Problem Description:

SMT components QFN 16-pin and QFN 28-pin are having insufficient solder volume at reflow. 0402 components are experiencing tombstone and solder ball problems at reflow. The assembly is also experiencing cold solder joints and poor wetting at reflow.

Allegro QFN 16-Pin
(red: termination, blue: SMT pad)

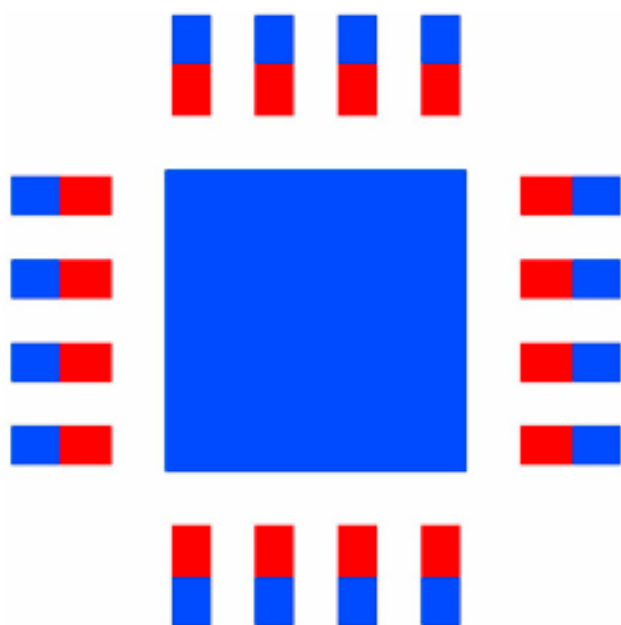
For leadless components, the terminal should cover 90%-100% of the SMT pad on the printed circuit board. On this assembly, the Allegro terminals cover 50% (terminal length is 0.0157" and SMT pad length is 0.0315") of the SMT pad and the Microchip terminals cover 47% (terminal length is 0.0157" and SMT pad length is 0.0335") of the SMT pad. The root cause of the insufficient solder volume is a result of too much surface area for the solder to wet to with enough left over to form an acceptable solder joint.

On leadless components, solder will uniformly wet to the surfaces of the terminal and SMT pad. When the terminal is 90%-100% of the SMT pad, solder is shared between the two surfaces. When the SMT pad is longer than the terminal, it creates surface area that is not shared between the two surfaces. Solder will be pulled from the joint during reflow to cover the additional surface area and the result is insufficient solder volume at the terminal.

Allegro QFN 16-pin: 0.0118" x 0.0415" (25% volume increase for terminals and 40% volume reduction for thermal pad)

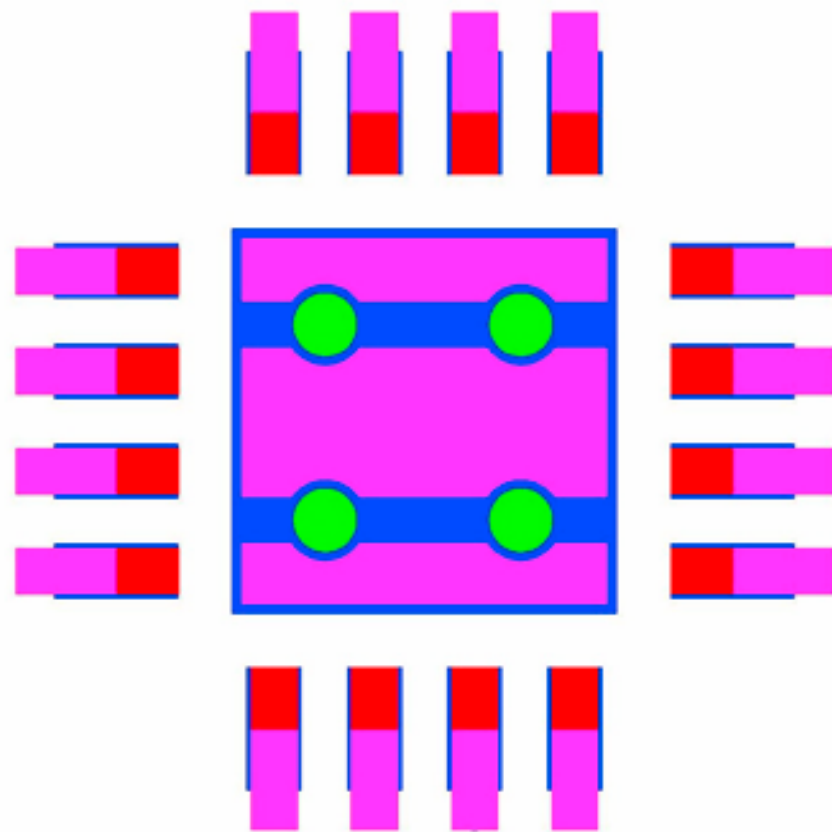
To eliminate the insufficient solder problems with the QFN components, the volume of solder printed must be substantially increased, given the small leadless terminals and large, comparatively, SMT pads. Fine Line Stencil has developed proven formulas that calculate the required volume increase eliminate the insufficient solder volume problem without causing bridging. The recommended stencil aperture size is as follows:

To minimize voids in the thermal pad, the four vias are not pasted. Applying solder paste around, but no directly over, the open vias minimizes the amount of flux and solder that gets lost to the via barrels. Voids in thermal pads with open vias are common not due to trapped gases, but insufficient solder volume. Not printing directly over the vias retains more of the solder volume for the joint between the PCB and component thermal pads.

Microchip QFN 28-pin: 0.0118” x 0.0445” (26.5% volume increase for terminals and 40% volume reduction for thermal pad)
(blue = SMT pad, red = IC foot, magenta = recommended stencil aperture)

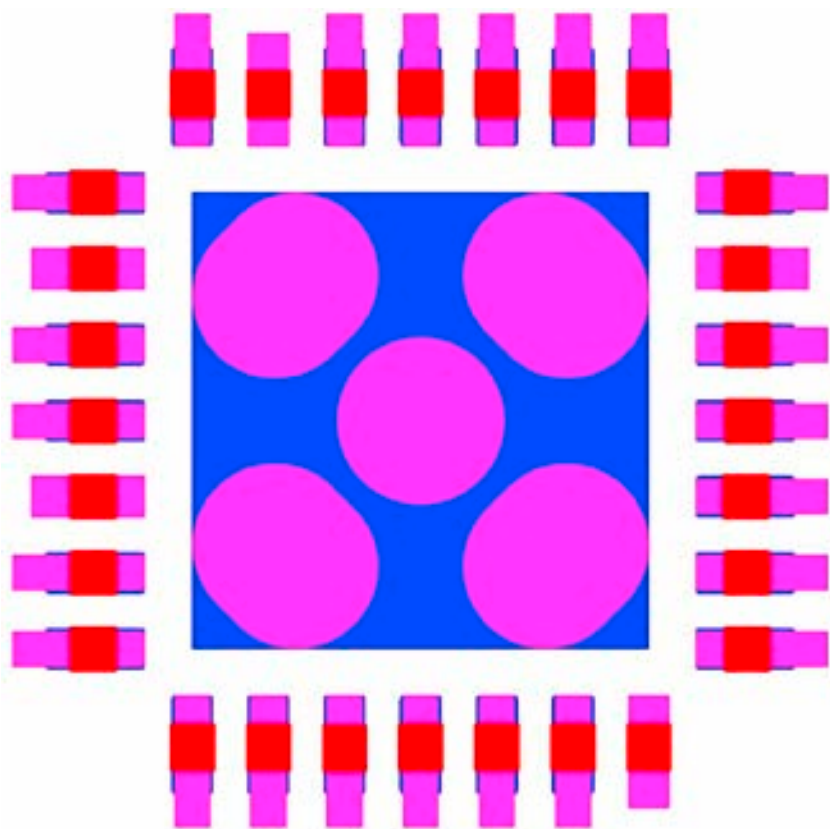
Some of the stencil apertures on the Microchip QFN are shorter and wider. This is due to the 0.0445” long aperture printing onto open vias. Solder volume will be lost to the open vias. The stencil apertures in several locations were shortened and widened to keep the same volume, but avoid the vias.
